PROJECT NAME: Miraflor Apartments (MSPM 19-008)

APPROVAL SOUGHT: Request for Major Site Plan modification approval to construct multifamily residential development consisting of 58 rental apartments within five (5), two/three-story structures with associated residential improvements on 3.87 acres zoned IPUD.

EXHIBIT "C"
CONDITIONS OF APPROVAL

Project Name: Miraflor Apartments
 File number: MSPM 19-008
 Reference: 3rd review plans identified as a Major Site Plan Modification with a February 11, 2020 Planning and Zoning Department date stamp marking.

SHEET TITLE:
PHOTOMETRIC PLAN

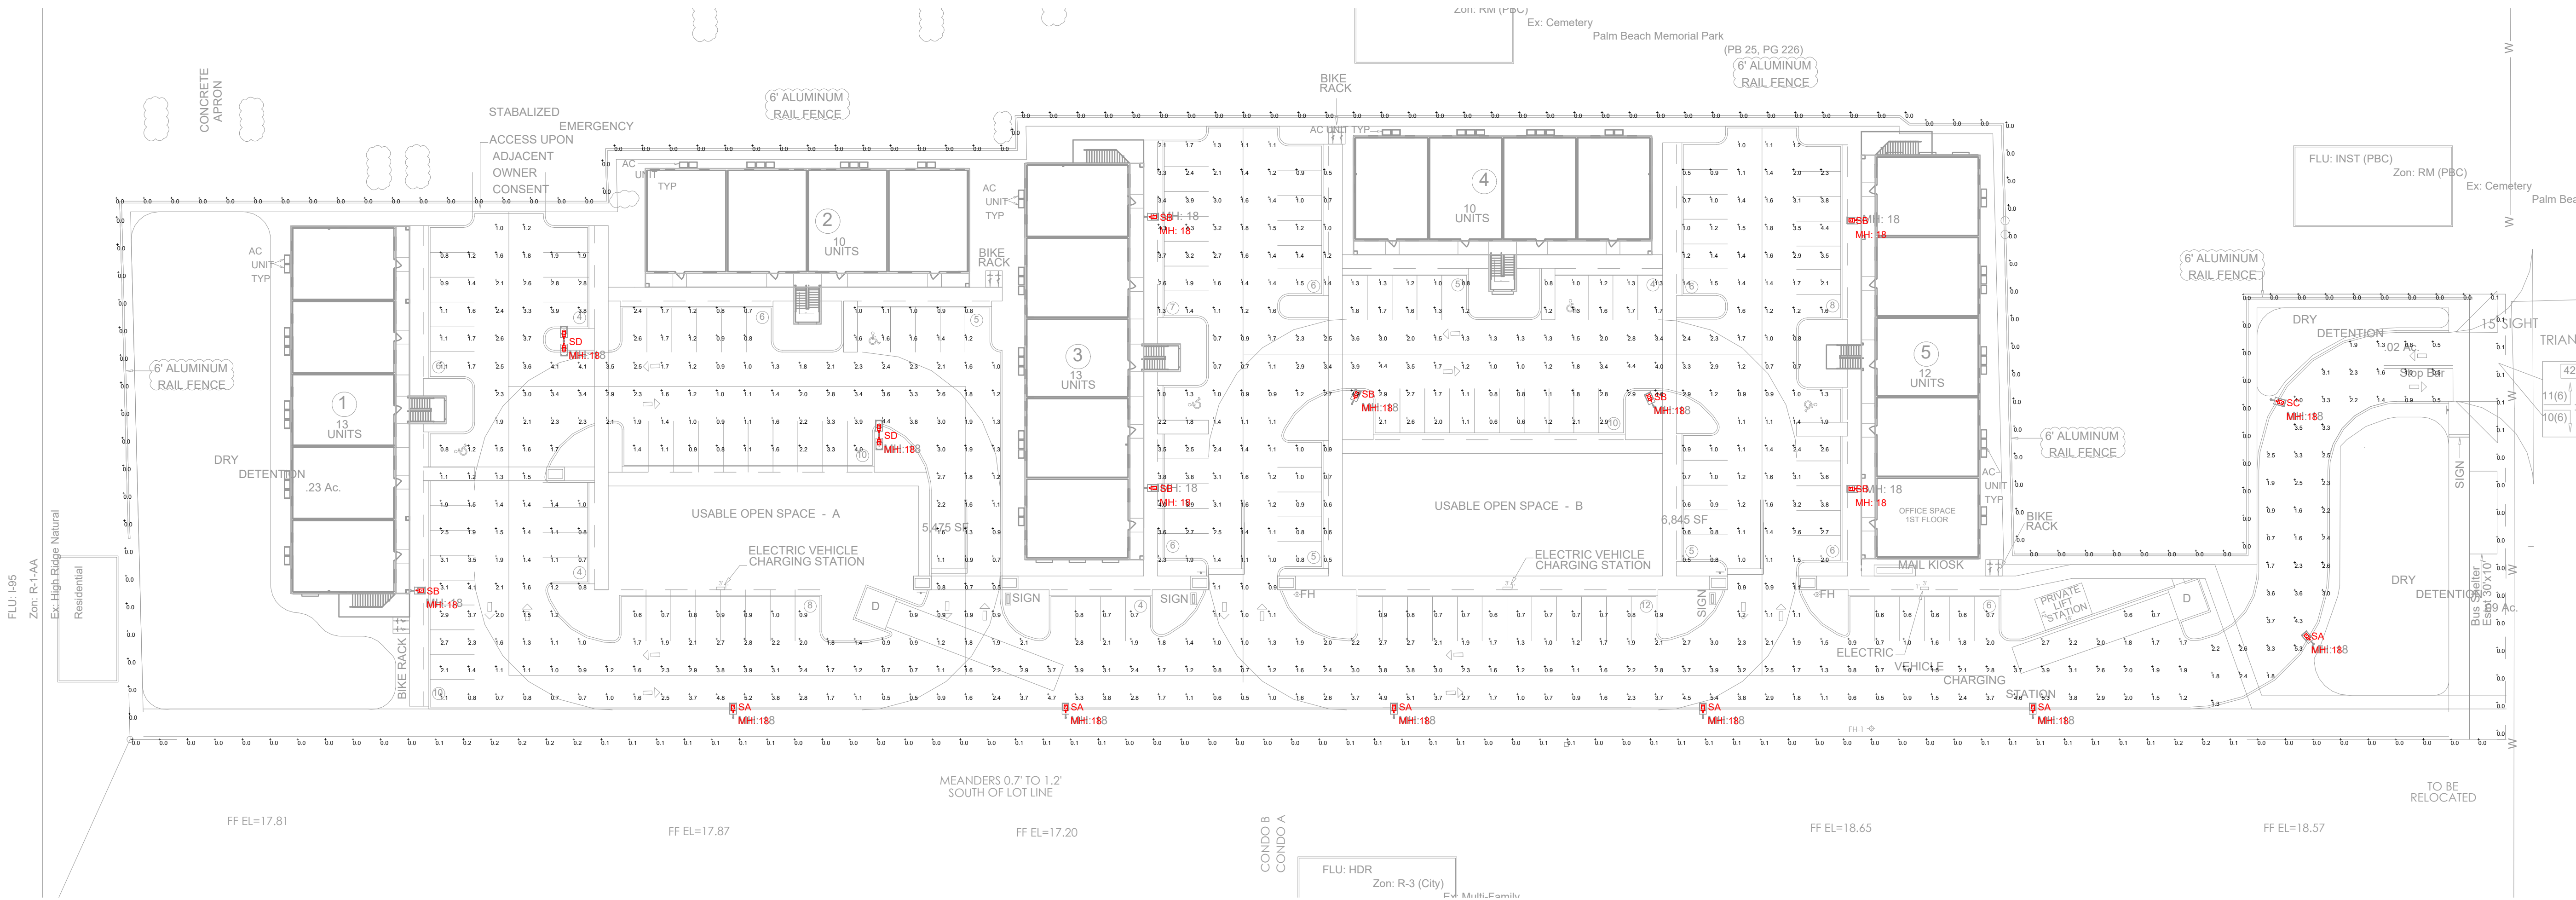
15. At time of permitting, revise photometrics plans to clearly indicate light fixtures will provide lighting in the warm white range of 2000 to 3000k.	√

16. At time of permitting revise photometrics plans to provide wall mounted lighting at building and apartment entries, including details of lighting fixtures and revised spot readings.	√
